# Determination 2026/004<sup>1</sup>

**An authority's decision to issue two notices to fix for building work carried out without consent, a change of use and non-compliance with the Building Code**

**11 Laurence St, Manly, Auckland**

**Figure 9: Current layout of ground floor (left) and first floor (right) showing locations of sanitary fixtures.**

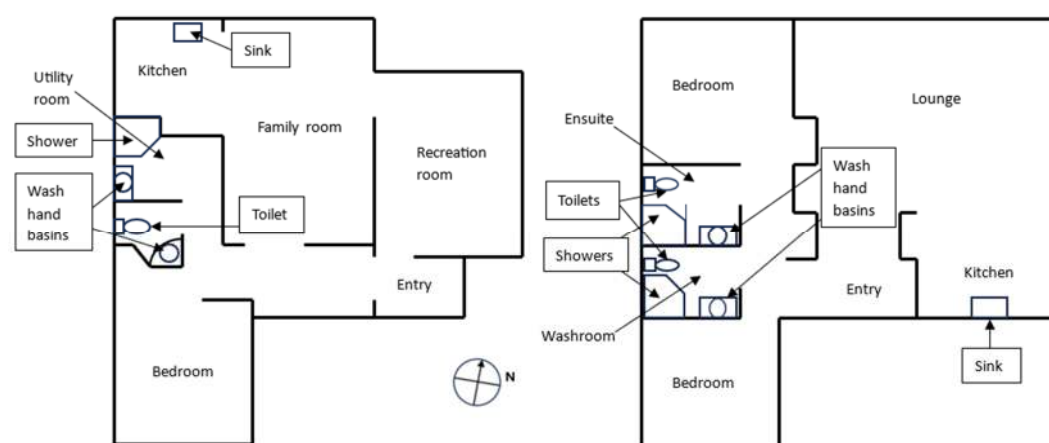
- The work was undertaken between September and December 2021. It appears the plumbing work has been completed although some sanitary fixtures have not yet been installed.
- The notice to fix refers to “The installation of new plumbing and drainage to support new sanitary fixtures...”. However, it does not specify which sanitary fixtures and associated plumbing work was ‘new’ or additional (rather than being replacement, repairs or relocation of previous fixtures and plumbing) nor the extent of any new drainage.
- The owners consider there are no additional sanitary fixtures or drainage connections, only replacement of existing, and the work is exempt under clauses 32 and 35.

- The COA did not include the installation of the sanitary fixtures or associated plumbing or drainage.
- As previously discussed, clauses 32 and 35 require the person(s) carrying out the work to be authorised under the PGDA. The owners have provided information that indicates this requirement has been met.<sup>26</sup>
- Due to a lack of the information about the plumbing and drainage, I have relied on information about the location of sanitary fixtures to get a broad understanding of the extent of the plumbing and drainage work that would have been necessary (see Figure 9). I have also received conflicting information regarding exactly what was present when the building was first constructed and then ‘lifted’ in 1968 (to form the two-storey building). In the absence of clear information, I have relied on the building permit plans from 1958,

<p>1968 and 1988, the COA plans from September 2020, and photographs provided by the parties.</p> <ul style="list-style-type: none"> <li>• Based on the information available, I conclude that at the ground floor level, there is a new/additional sink (in the kitchen) and an extra wash hand basin, and these would have required the installation of new fixture discharge pipes. At the first-floor level, there is a new/additional toilet, shower and wash hand basin in the ensuite, a space that was previously occupied by the first-floor kitchen where there had been only a single discharge pipe for the kitchen sink. The additional fixtures would have required the installation of new fixture discharge pipes.</li> <li>• The alteration/relocation of the plumbing associated with the existing sanitary fixtures was exempt under clause 35. However, the work to install new plumbing in relation to the additional sanitary fixtures (that increase the number of sanitary fixtures in the building) does not meet the criteria in clause 32 or 35.</li> </ul>
